53GBaud links:
updated receiver status (in reply to Piers's
comment ID #46).

10th May 2017
P802.3cd ad hoc
Marco Mazzini

mazzini_02a_1215_smf.pdf

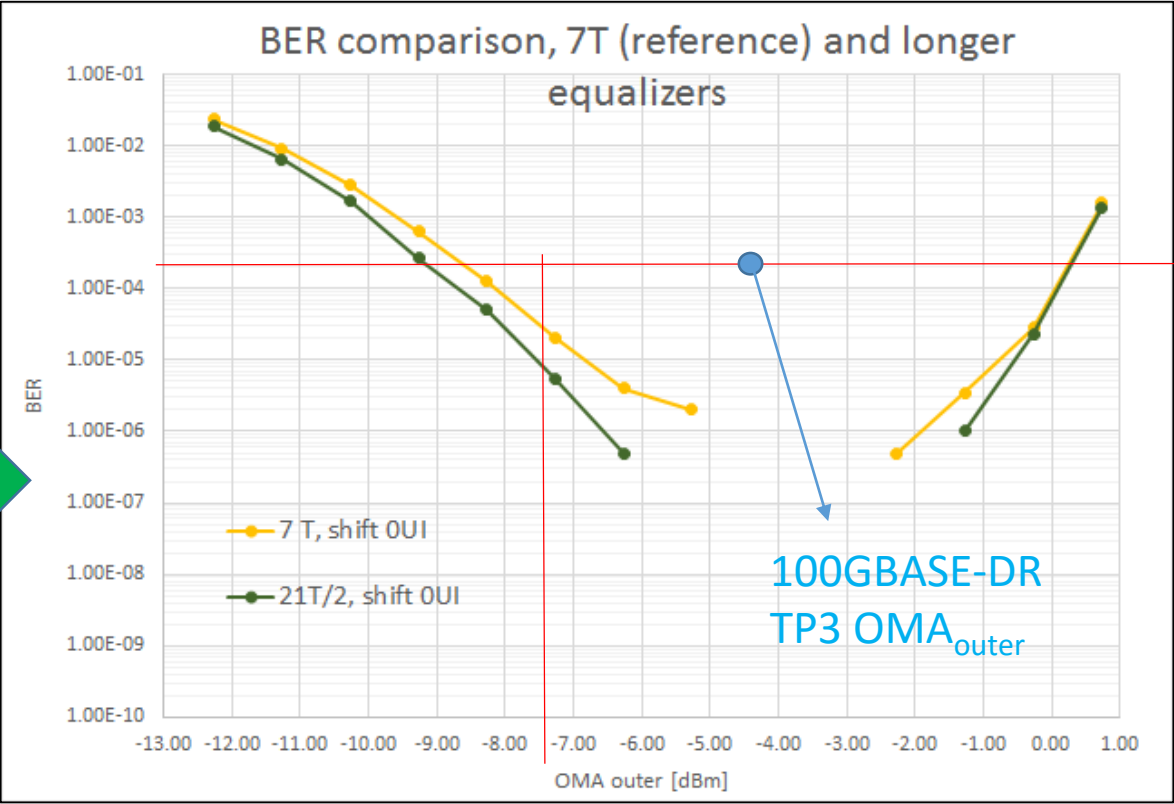
Experimental results on different parts confirm that $< -8.3\text{dBm OMA}_{\text{outer}}$ was the correct forecast.

We can consider above right curve as reference sensitivity value for different RX assemblies, with respect a reference receiver of 'normalized' parameters such:
